# Accessibility Survey

## City of Downey Rosecrans Avenue & Century Boulevard

Date of Inspection  
4/21/2017

**Disability Access Consultants**

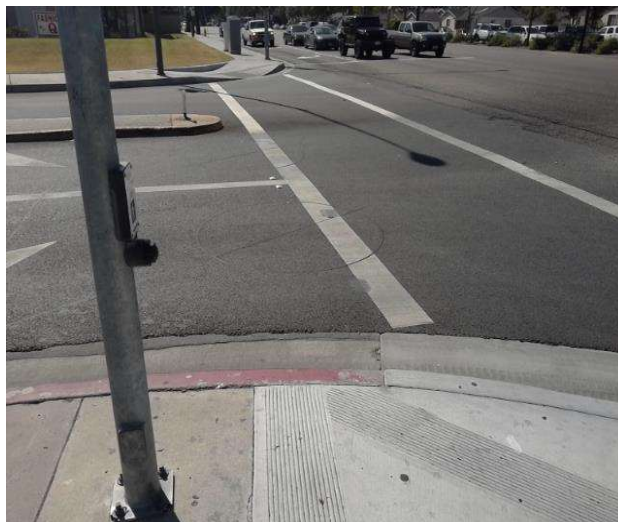
Push button distance from crosswalk is not compliant.

**On-Site Finding** 148.00 inches

Provide a compliant push button.

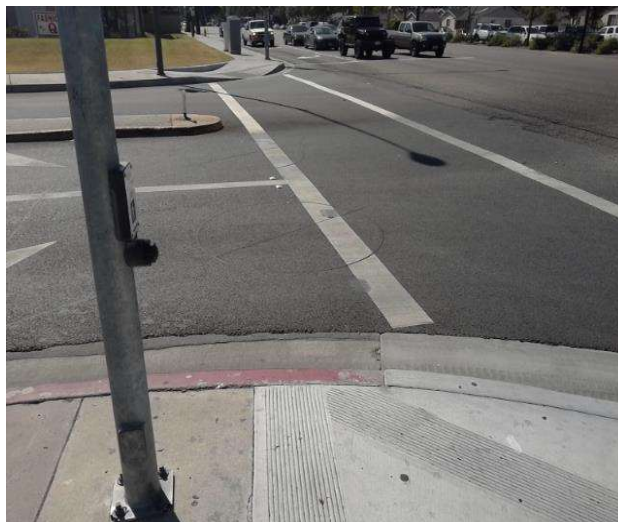
There is not enough clear ground space at the push button.

**On-Site Finding** 26.50 inches

Provide compliant clear ground space at the push button.

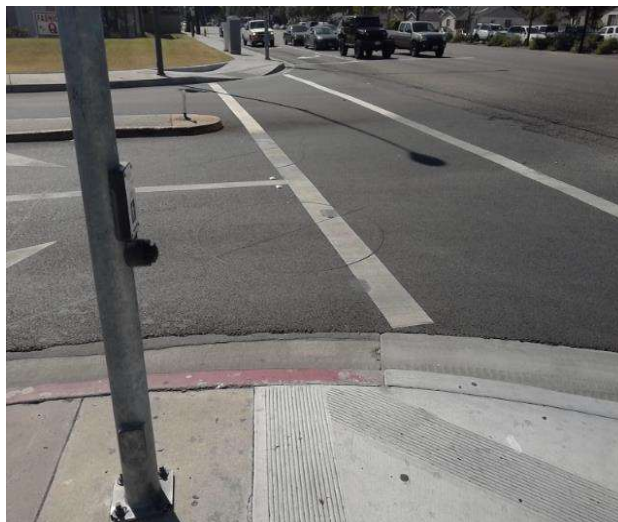
There is no street name information related signage at the signal.

**On-Site Finding** Not Found

Provide compliant signage that includes street name.

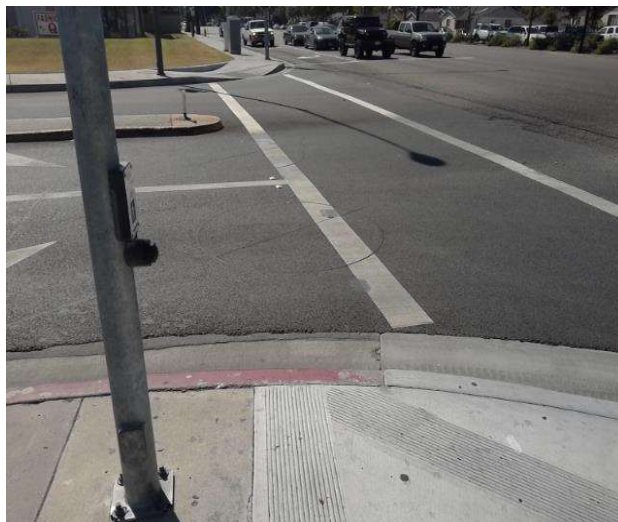
There is no crosswalk map provided at the signal.

**On-Site Finding** Not Found

Provide a crosswalk map.

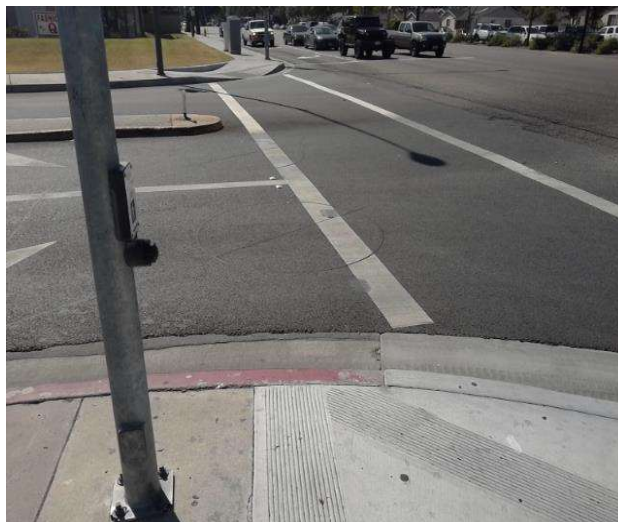
No locator tone provided for the pedestrian signal indicator.

**On-Site Finding** Not Found

Provide locator tone for the indicator.
